REF: MAL/12474/

### **RESPONSE ON COMMENTS ON THE DRAFT BASIC ASSESSMENT REPORT FOR THE PROPOSED ESTABLISHMENT OF A 132 KILOVOLT(KV) OVERHEAD POWERLINE (DE HOOP 132KV OVERHEAD POWERLINE)**

**COMMENT ON THE DRAFT BASIC ASSESSMENT REPORT (“BAR”) SUBMITTED IN TERMS OF THE NATIONAL ENVIRONMENTAL MANAGEMENT ACT, 1998 (ACT NO. 107 OF 1998) (“NEMA”) AND THE ENVIRONMENTAL IMPACT ASSESSMENT (“EIA”) REGULATIONS, 2014 (AS AMENDED) FOR THE PROPOSED ESTABLISHMENT OF 132 KILOVOLT (KV”) OVERHEAD POWERLINE (DE HOOP 132KV OVERHEAD POWERLINE) AND LOOP-IN, LOOP-OUT FROM THE ESKOM NATIONAL ELECTRICITY GRID TO THE EXISTING DE HOOP HOUSING DEVELOPMENT SUBSTATION THAT WILL TRAVERSE THE REMAINDER OF THE FARM NO. 1113, PORTION 18 OF THE FARM NO. 766, PORTION 13 OF THE FARM NO. 766, THE REMAINDER OF PORTION 8 OF THE FARM NO. 766, PORTION 24 OF THE FARM NO. 766, THE REMAINDER OF PORTION 15 OF THE FARM NO. 766 AND ERVEN 373, 12081 AND 12496, MALMESBURY**

Average height of Airstrip:

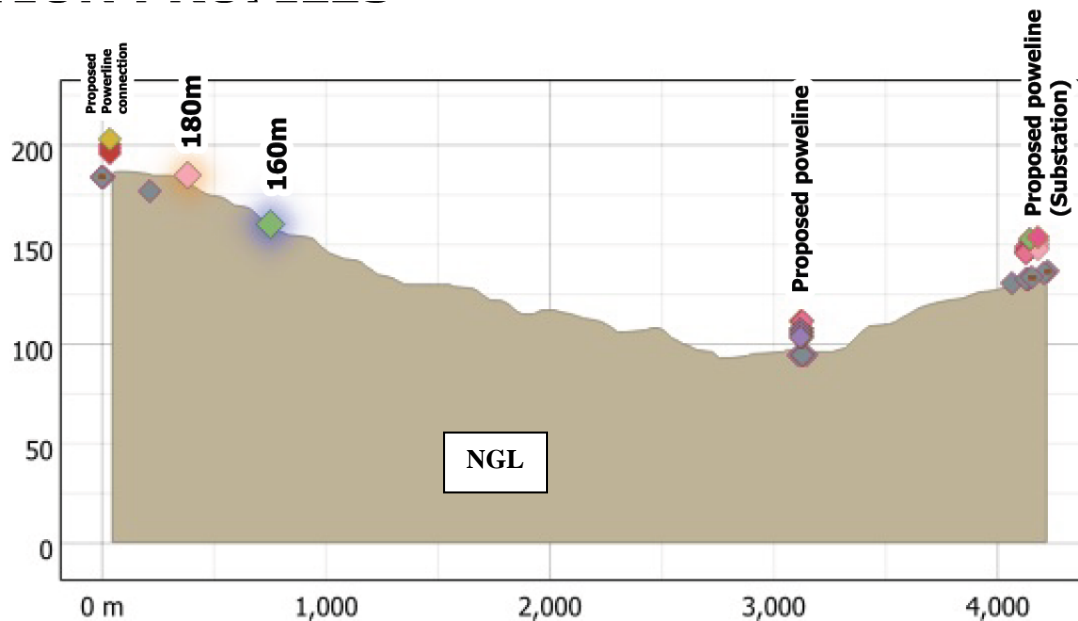
In the absence of obtaining a published reference elevation for this particular aerodrome, the average height of the aerodrome was calculated by averaging the elevations of all contour lines intersecting the airstrip runway. As shown below, the airstrip crosses 41 contours, resulting in an average elevation of 140 meters.

By comparing the average elevation of the airstrip with the definition of the Inner Horizontal Surface, it has been determined that the Inner Horizontal Surface is situated at an elevation of 185 meters.

Given that the pylons for the proposed powerline route have a height of 20 meters, any section of the powerline situated below a contour elevation of 160 meters will remain beneath the inner Horizontal Surface. Consequently, the proposed route will not intrude into the airspace or interfere with flight paths.

### Elevation Profile 1:

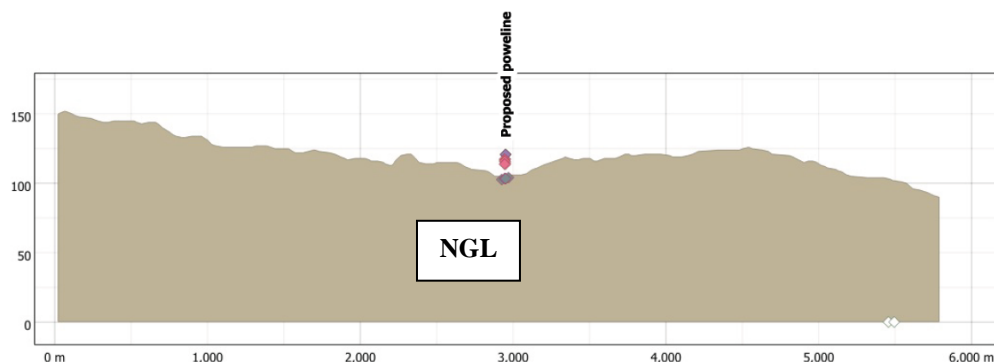
**2.3.3.** According to the correspondence received by the objectors, the location of the proposed route will have a direct impact on the health and safety of the aircraft, pilots and other personnel at the aerodrome, this includes:

<p><b>2.3.3.1.1.</b> Potential catastrophic events caused by pilots have more limited options of evading danger.</p>	<p>It is important to clarify that the intersections between the flight paths and the proposed 132 kV powerline route fall within the ‘Inner Horizontal Surface’ airspace zone. The proposed powerline route remains below the threshold level of the Inner Horizontal Surface at these crossing points. As such, the potential impact on the flight paths is considered negligible.</p> <p>Given the proposed powerline’s compliance with airspace regulations and its placement below critical aviation height restrictions, the risk to aviation safety and the ability of pilots to evade potential hazards is significantly minimised. Additionally, the alignment of the powerline ensures that it does not protrude into areas that would present a substantial obstruction to aircraft operations, other</p>

Consists out of a depiction of a straight line from the exact position where the

proposed powerline route connects with the existing 132 kV main regional line and where to the proposed powerline route connects with the substation, situated north of the connection point.

As illustrated in the elevation profile above only a small segment of the proposed powerline route exceeds the height of 180 meters, which is defined as the Inner Horizontal Surface.

As previously noted in our response, it is crucial to emphasise that the only instance where the proposed powerline route intersects with the Inner Horizontal Surface occurs at the point of connection with the existing line.

**Elevation Profile 2:**

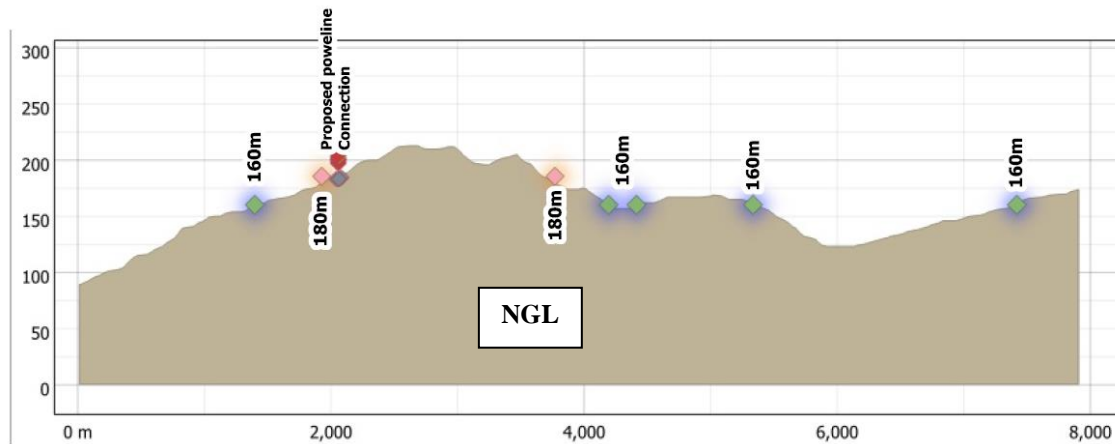
the organisation and community.	be implemented.
<b>2.3.3.4.</b> The adjusted location of the proposed powerline:	
<b>2.3.3.4.1.</b> Still intersects directly with the two main flight paths.	As presented in our response on the comments, these intersections is situated below the Inner Horizontal Surface, and therefore is considered to have a insignificant effect on the flight paths.
<b>2.3.3.4.2.</b> Can drastically affect the business of the WPO.	<p>Please refer to our previous responses, which provide detailed insights and justifications demonstrating that the proposed powerline route will not adversely affect the business operations of WPO. The alignment has been carefully planned to comply with all relevant standards and regulations, ensuring that any potential impact on the functionality and safety of the aerodrome is minimised.</p> <p>With these considerations in place, it is not anticipated that the powerline will disrupt WPO's business activities or operational capabilities. The proposed route has been designed to coexist with existing infrastructure without compromising safety or operational efficiency.</p>

This section includes a depiction of the flight path extending in a westerly direction over the proposed powerline route. As illustrated in the elevation profile below, the flight path intersects the proposed powerline at a location where the pylon is situated at an elevation of 105 meters. When accounting for the height of the pylon, this intersection is effectively at a height of 125 meters.

Additionally, it is important to note that the intersection occurs approximately 1550 meters from the northernmost point of the airstrip.

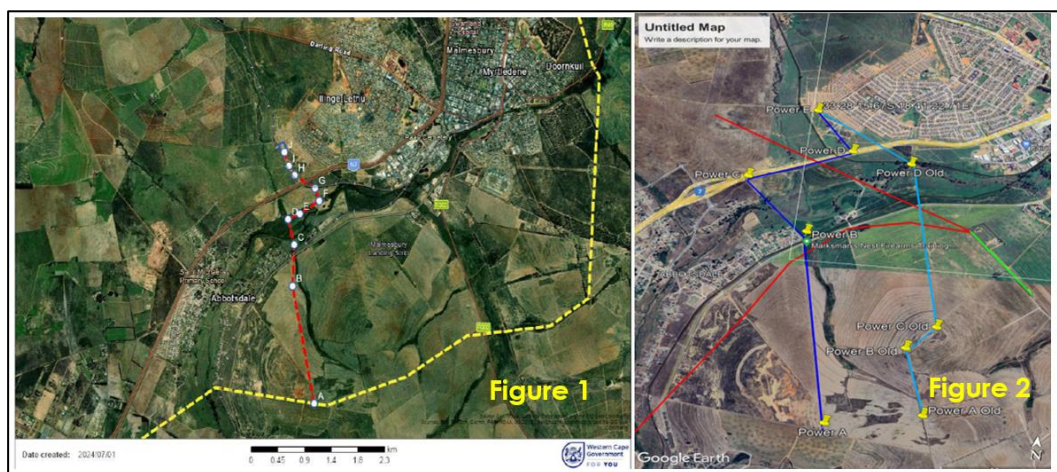
2.3.1. Based on the two (2) images below, it appears that the current proposed powerline, as extracted from figure 1 of the draft BAR (figure 1 below) is not the same as the powerline route as the dark blue line in figure 2 below (extracted from the correspondence of Westerlike Provinsie Oesbespuiting Maatskappy (Pty) Ltd ("WPO") (dated 22 November 2023):

2.3.2. Therefore, please ensure that comments from the WPO is obtained on the latest powerline route, as depicted in figure 1 above. The comments obtained must be adequately responded to, and proof thereof included in the Comments and Responses Report.

We acknowledge the observation regarding the discrepancy between the powerline route depicted in Figure 1 of the draft Basic Assessment Report (BAR) and the route as extracted from the correspondence of WPO, dated 22 November 2023.

It is important to note that WPO responded in writing on 12/12/2022, during the land-use Public Participation Process of the proposed powerline. WPO's response was evaluated against ESKOM's

Updated maps and route alignment have been provided to WPO for review, and additional comments were requested to ensure accuracy. In an E-mail dated 29 July 2024, WPO confirmed that their comments remain unchanged despite the efforts of proposing alterations to the proposed Powerline. We will continue to seek their feedback and support on the latest proposed powerline route. Once their comments are obtained, we will ensure that they are thoroughly addressed, and corresponding proof will be included in the Comments and response.

The revised powerline route has been assessed in accordance with the requirements outlined in the relevant documents and legislation, and it complies with all the applicable criteria. The proposed route remains below the “Inner Horizontal Surface” throughout its course, apart from the section where it connects to the existing main regional powerline. From this connection point, the line immediately descends towards the Dieprivier and stays below the ‘Inner Horizontal Surface’ until it reaches the substation.
